# Planning Assessment Officer Report

Application No: PA2504008  
20 Eastwood Street, BALLARAT CENTRAL  
(Eastwood Leisure Complex)

Figure 16: Proposed demolition and development summary

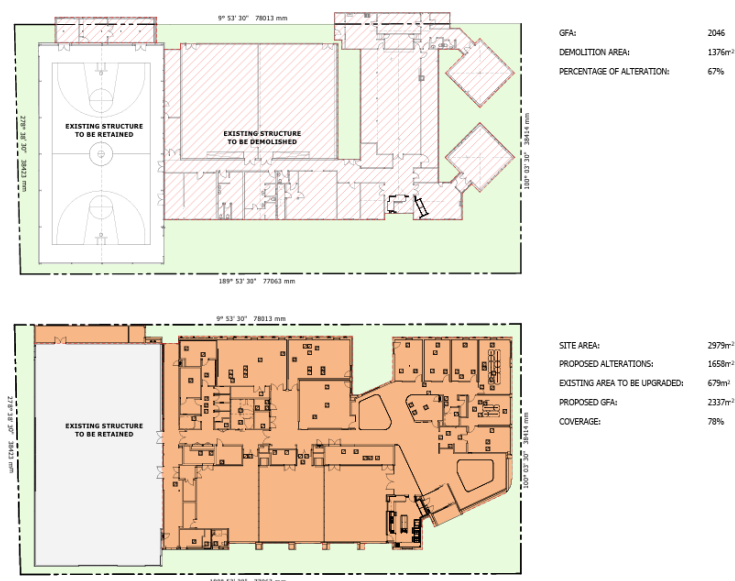
38. The subject site is located within a commercial precinct with predominantly commercial single storey interfaces and limited built form sensitivities and does not propose an increase to the existing maximum building height on site. The existing basketball stadium (gym) forms the highest point on site at 8.5m, noting that the structure is to be retained and re-clad. The new structure and remainder of the development is proposed to have a maximum building height of 6.75m. The height remains of a low scale and has a building footprint that reflects the existing structures on site, with setbacks largely maintained (Figure 16).

39. The single storey height and maintained setbacks along the eastern frontage is a positive outcome as the proposal will have negligible impact upon the neighbouring childcare centre and reserve. Overshadowing and visual bulk impacts will remain relatively unchanged.

Figure 17: Proposed north elevation

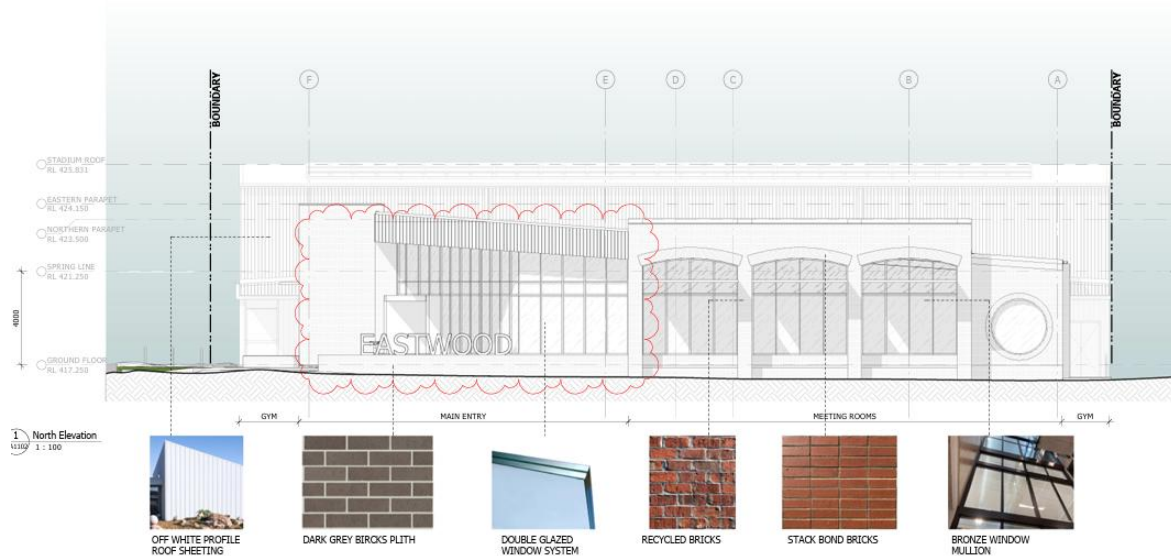
40. The proposed design remains sympathetic to the surrounding built form context of commercial uses, as well as the heritage character of the surrounding heritage precinct. The proposed design features a combination of stack bond and recycled brick, and large double-glazed windows along the primary frontages to the north and east of the site. The glazing treatment to these frontages allows for a significantly improved street presence and passive surveillance outcome for a community asset (Figure 17). Landscaping proposed along the northern and western interfaces integrates with the existing setbacks and creates a visual break from the predominantly concrete/clad commercial environment to the north.

42. The existing basketball stadium (gym) refurbishment achieves a more subdued façade expression in keeping with its scale and role alongside the community centre (new building). The off-white roof sheeting provides a refreshed and modern façade treatment while still referencing the architectural language of the community centre. The use of two sheeting profiles provides a subtle rhythm aligned with the lower height and expression of the adjoining built form (Figure 18).
